Access Compliance Report

Public Rights-of-Way

(Pedestrian Signals)

Intersection ID: N/A	Main Street:	Cross Street: N/A	Location: N/A
ADA ID: 434962155899	Signal Type: Two Push Buttons-Non APS	Overall Compliance: No	Severity Score: BTN 1:N/A BTN 2: N/A No BTN: N/A
Codes/Mitigation Info/Possible Solution		Field Measurements/Component Compliance

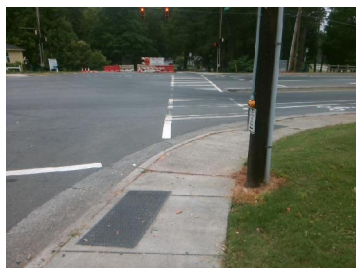
PROW/ADA: R404.1, R406.2, R404.2, R404.3

Compliance	Description	Data	Compliance	Description	Data
	Button Count	Button2	N/A	Distant to Additional Button (in)	N/A
	Additional Button Present?	N/A		Additional Button ID	N/A
N/A	Signal Buttons Required?	N/A	N/A	Additional Ped Posts Required	N/A
	How Many Ped Street Xings?	2		Located In An Island/Median?	No
N/A	B 1 Sign Present?	Yes	N/A	B 2 Sign Present?	Yes
Yes	B 1 Sign Purpose?	Yes	Yes	B 2 Sign Purpose?	Yes
Yes	B 1 Sign Lettering & Contrast?	Yes	Yes	B 2 Sign Lettering & Contrast?	Yes
Yes	B 1 Parallel To XWalk?	Yes	Yes	B 2 Parallel To XWalk?	Yes
Yes	B 1 PAR to Button?	Yes	Yes	B 2 PAR to Button?	Yes
Yes	B 1 PAR to XWalk?	Yes	Yes	B 2 PAR to XWalk?	Yes
No	B 1 Clear Floor Space?	No	Yes	B 2 Clear Floor Space?	Yes
N/A	B 1 FWD Approach?	Yes	N/A	B 2 FWD Approach?	Yes
N/A	B 1 FWD Approach Constrained?	No	N/A	B 2 FWD Approach Constrained?	No
No	B 1 FWD Approach Reach (in)	16.0	No	B 2 FWD Approach Reach (in)	3.0

N/A	B 1 FWD Approach Width (in)	N/A	N/A	B 2 FWD Approach Width (in)	N/A
N/A	B 1 FWD Approach Obstruction?	No	N/A	B 2 FWD Approach Obstruction?	No
N/A	B 1 FWD Approach Obstruction Dist (in)	N/A	N/A	B 2 FWD Approach ObstructionDist (in)	N/A
N/A	B 1 PARA Approach?	No	N/A	B 2 PARA Approach?	Yes
N/A	B 1 PARA Approach Constrained?	N/A	N/A	B 2 PARA Approach Constrained?	No
N/A	B 1 PARA Approach Reach (in)	N/A	Yes	B 2 PARA Approach Reach (in)	3.0
N/A	B 1 PARA Approach Width (in)	N/A	N/A	B 2 PARA Approach Width (in)	N/A
N/A	B 1 PARA Approach Obstruction?	N/A	N/A	B 2 PARA Approach Obstruction?	No
N/A	B 1 PARA Approach Obstruction Dist (in)	N/A	N/A	B 2 PARA Approach ObstructionDist (in)	N/A
N/A	B 1 Clear Floor Space Slope (%)	N/A	No	B 2 Clear Floor Space Slope (%)	3.2
N/A	B 1 Clear Floor Space XSlope (%)	N/A	No	B 2 Clear Floor Space XSlope (%)	11.3
N/A	B 1 PAR Slope (%)	2.5	N/A	B 2 PAR Slope (%)	2.2
Yes	B 1 Height (in)	42.0	Yes	B 2 Height (in)	43.0

Possible Solutions: Provide Clear Space.
Provide Push Button Extension. Remove and Replace Clear Space.
